**DRAFT FINAL SITE INSPECTION WORK PLAN, PRELIMINARY ASSESSMENT,
OTHER AREAS/UTILITIES, VOLUME 1 OF 3 - UNDERGROUND UTILITIES**

DRAFT FINAL
SITE INSPECTION WORK PLAN: PA OTHER AREAS/UTILITIES
VOLUME I of III: UNDERGROUND UTILITIES
NAVAL STATION, TREASURE ISLAND
HUNTERS POINT ANNEX
SAN FRANCISCO, CALIFORNIA

NAVY RESPONSES TO COMMENTS ON DRAFT SI WORK PLAN:

The following are the Navy's responses to comments by the U. S. Environmental Protection Agency (EPA), Region IX, on the Site Inspection Work Plan: PA Other Areas/Utilities, Volume I of III Underground Utilities, Naval Station, Treasure Island, Hunters Point Annex. The EPA presented their comments in a letter dated February 12, 1992.

PLATE
6

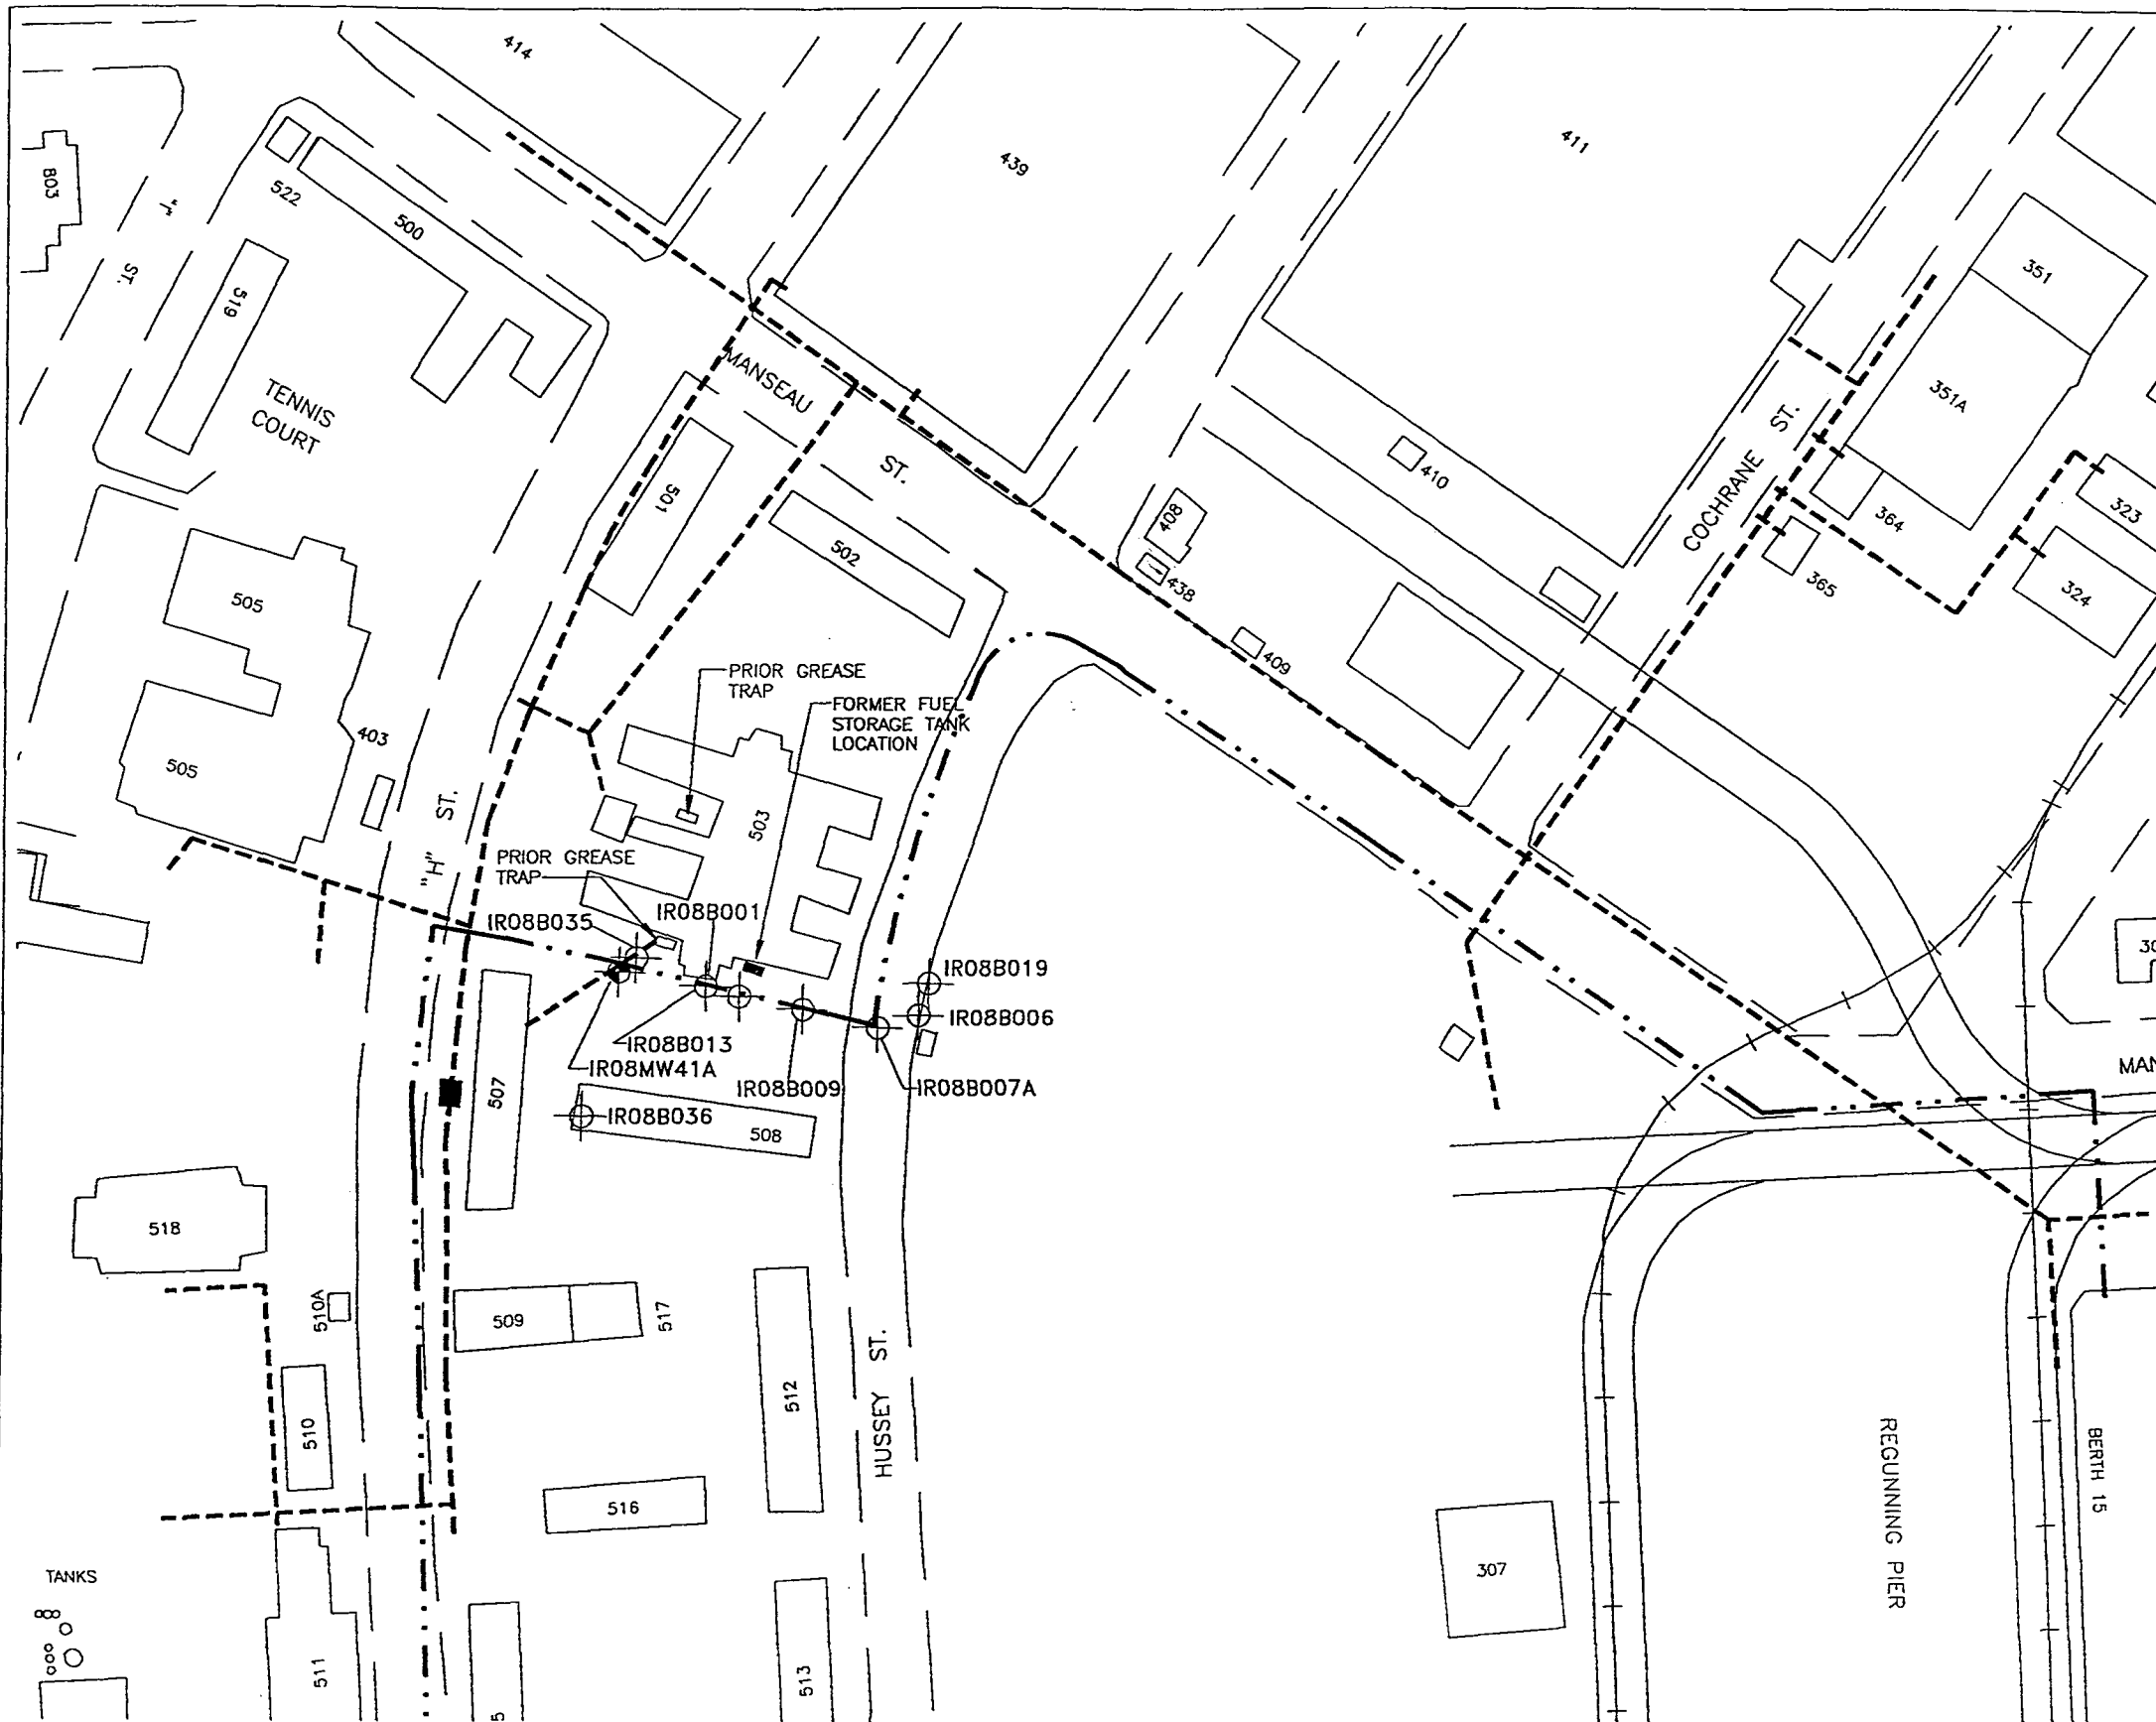
(d) The EPA report of information provided by the former HLA employee states that the line runs southwest along H Street toward the Power Plant, but examination of the map shows that H Street runs to the southeast. As compass directions seem to be inaccurate, both the west side of Hussey Street (as stated in the EPA report of HLA employee information) and the east side of Hussey Street and south side of Manseau Street (as shown in plate 6) should be investigated for the presence of buried lines.

Harding Lawson Associates		Fuel Distribution Lines, Building 205 (PA-49)		7
	Engineering and Environmental Services		Site Inspection Work Plan: Underground Utilities		
			Hunters Point Annex		
		San Francisco, California			
DRAWN CEG		JOB NUMBER 18639,616.02		APPROVED BPF	
				DATE 10/91

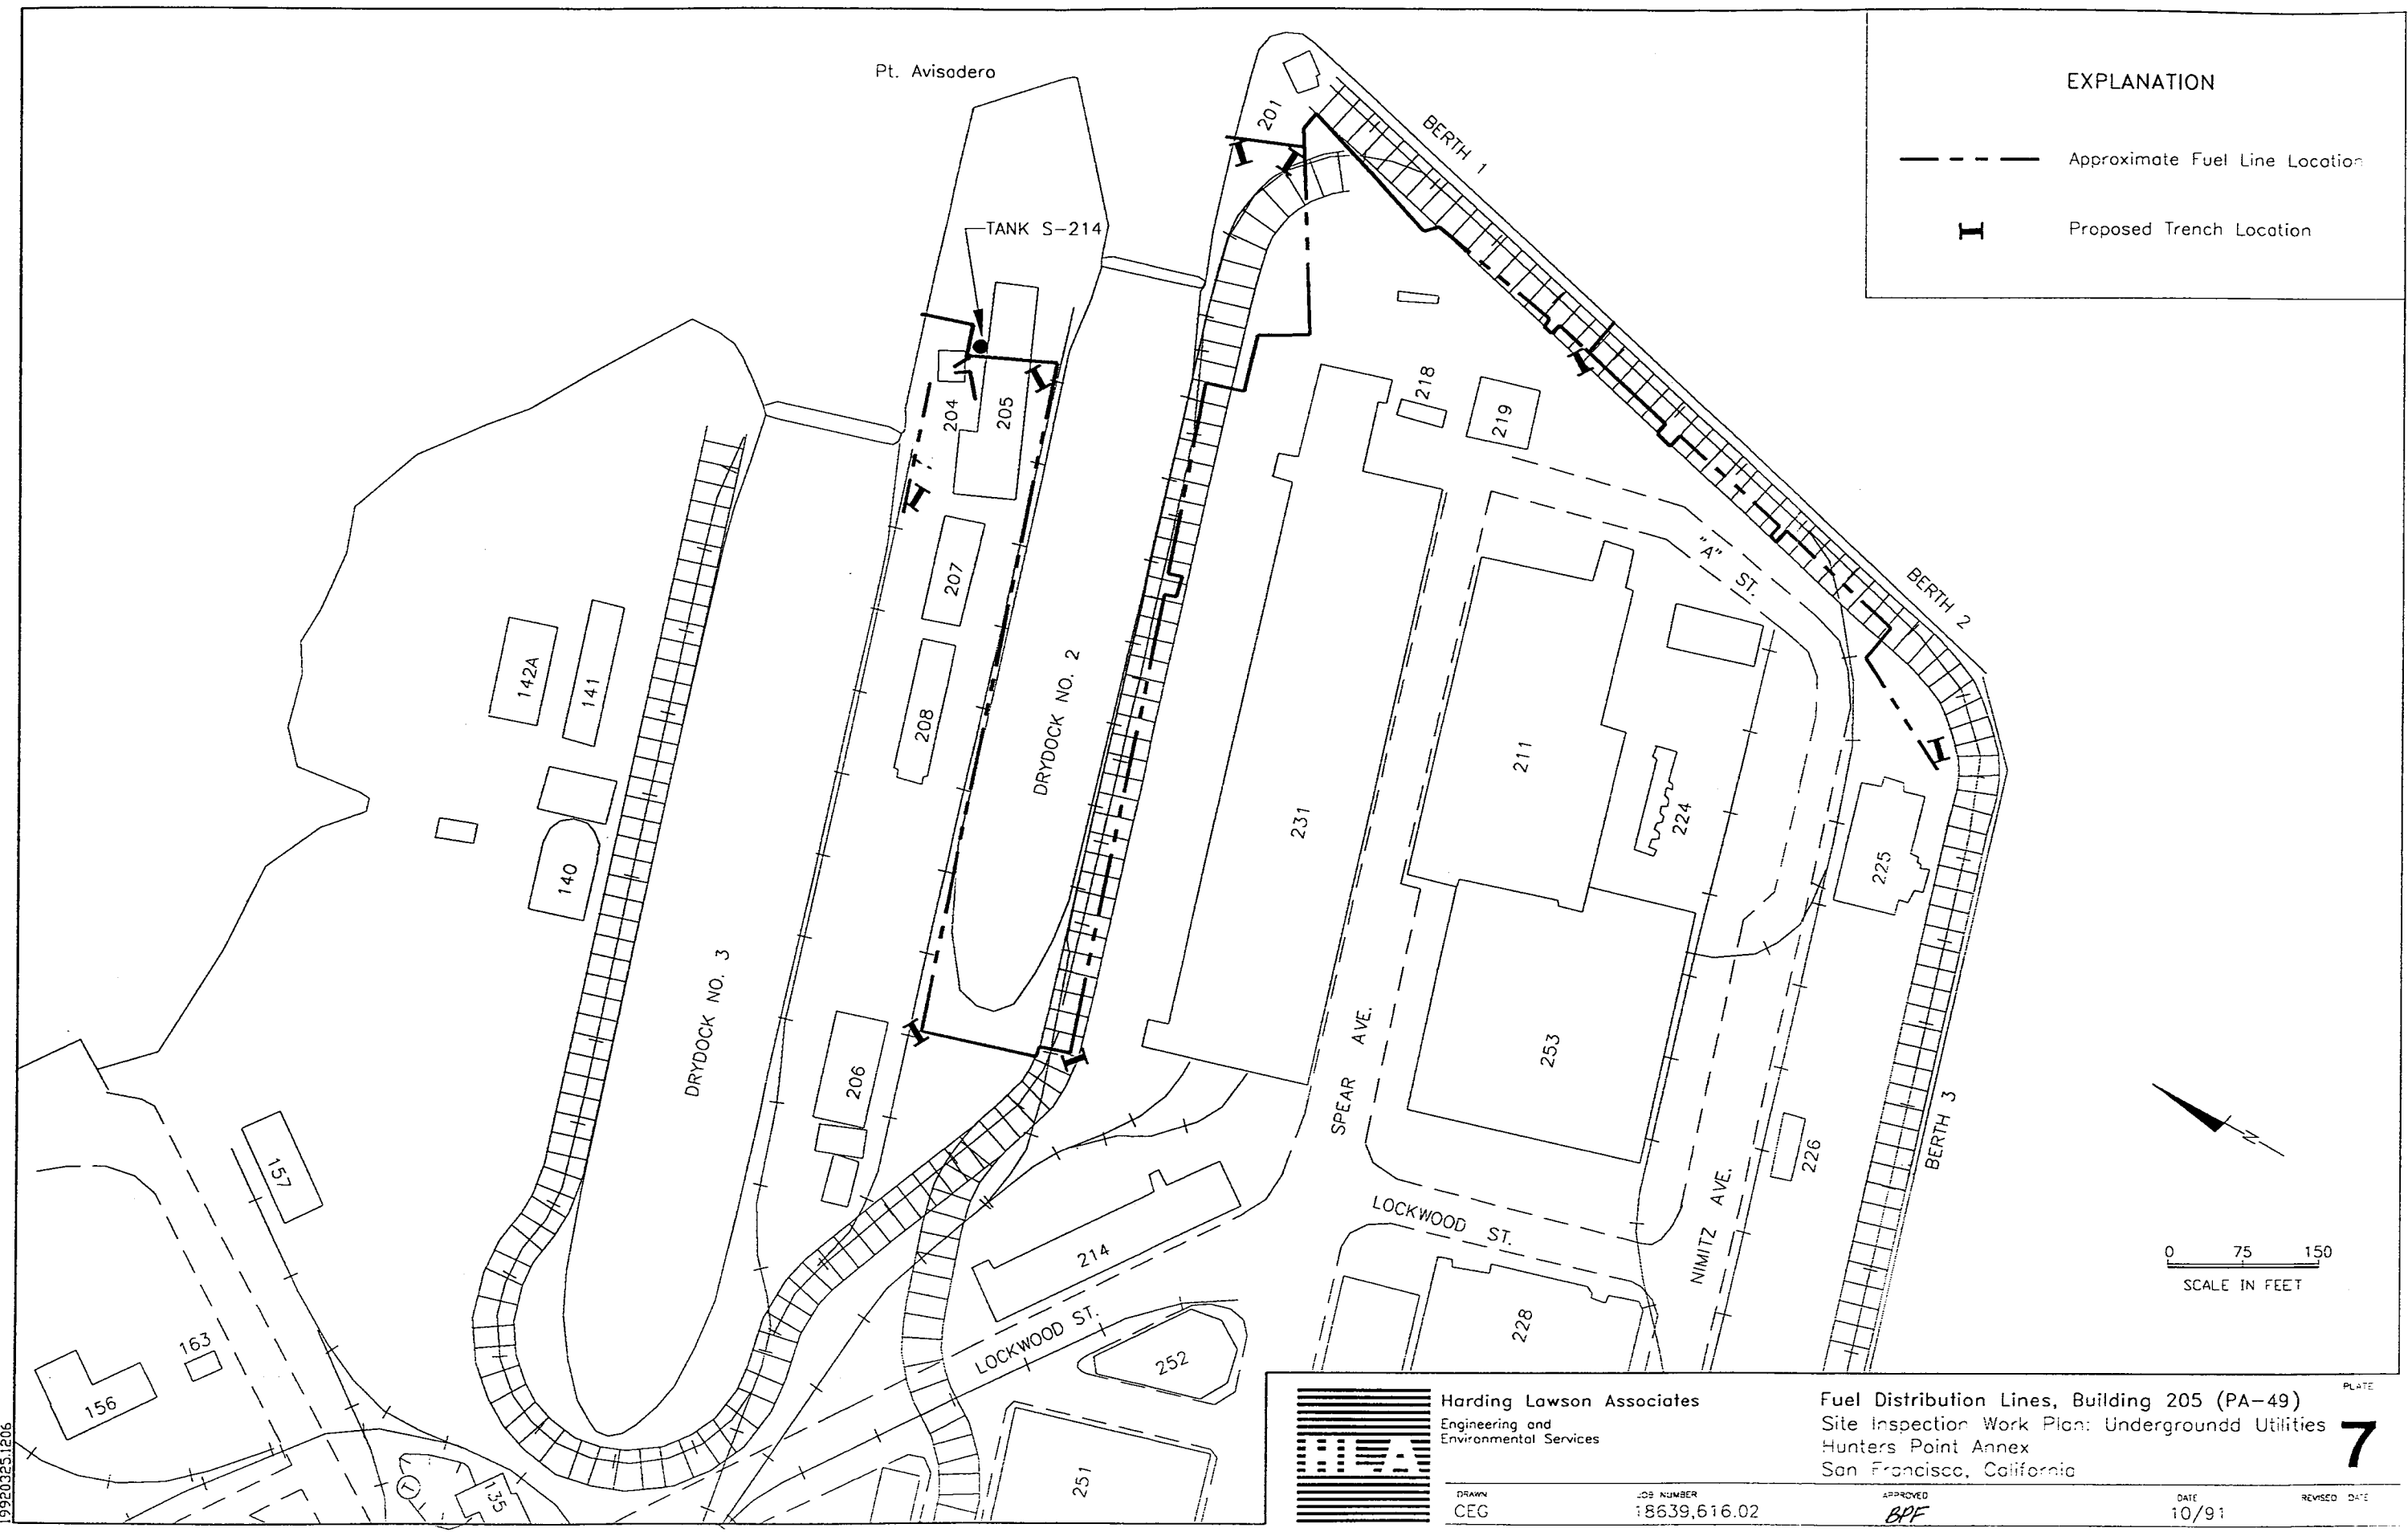
p. 20, Section 2.3.5.3, and Table 3: Table 3 states that 8 soil samples will be taken for Building 205 and 8 trenching locations are shown on Plate 7. Plate 8 shows 5 proposed trench locations for the vicinity of Building 203, but the disposition of samples from those trenches are neither discussed in the text nor reflected in the number of samples to be analyzed in Table 3. Please show the samples to be taken from the vicinity of Building 203 on Table 3 and discuss them in the text where appropriate.

One tank (S-214) has been identified between Building 204 and Building 205. This tank was used to store fuel for the boiler units located in Building 205. The location of this tank has been added to Plate 7. According to HPA facility control drawings, the lines were used to transport diesel fuel.

Fuel Distribution Lines, Building 203 (PA-49)
Site Inspection Work Plan: Underground Utilities
Hunters Point Annex
San Francisco, California

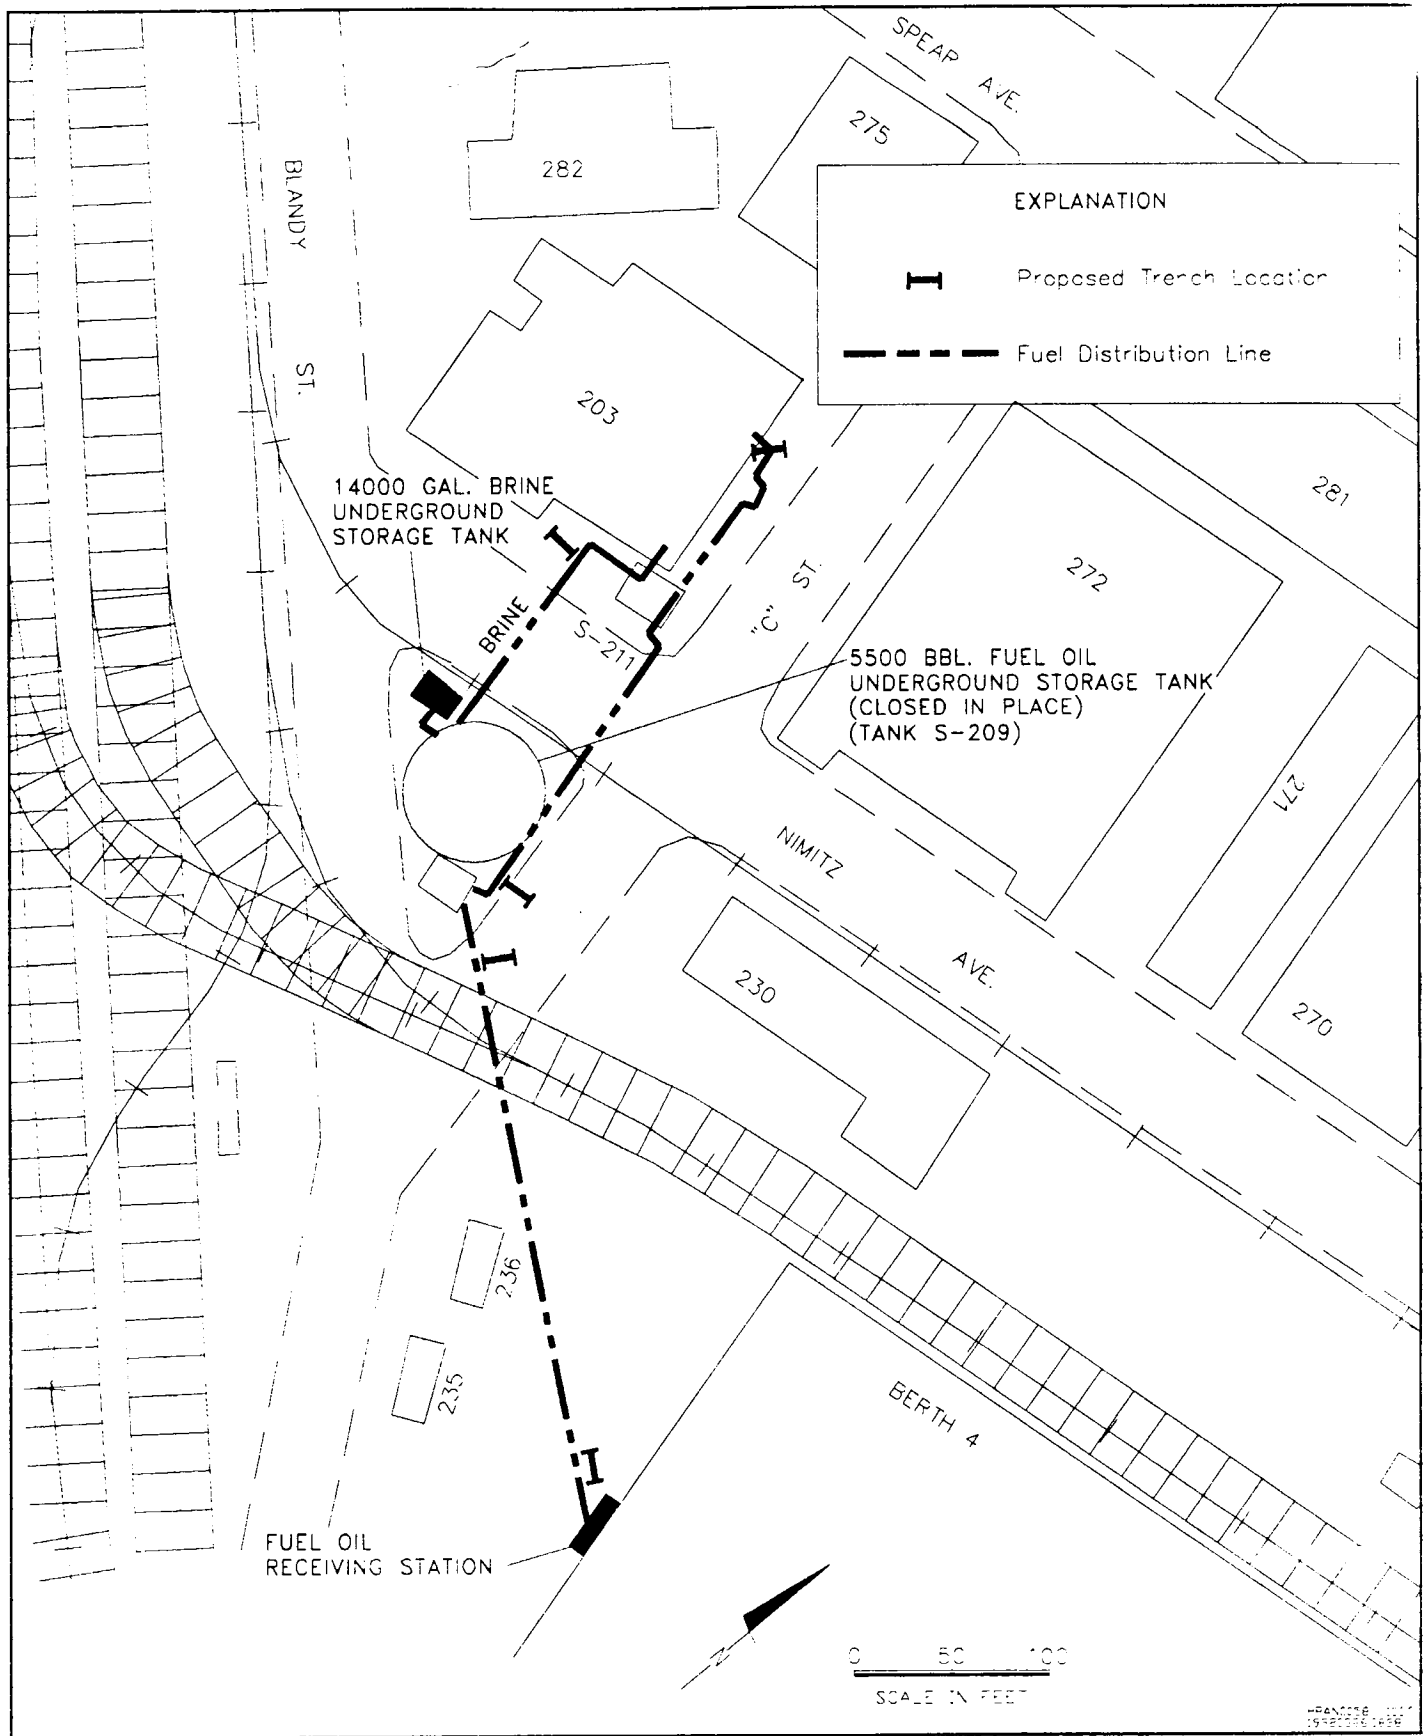
Page 19, Section 2.3.5.2 and Table 3. Clarify scope of sampling. Plates 7 and 8 show 13 trench locations and Table 3 provides for analysis of 8 samples. This provides for less than one sample at each trench location.
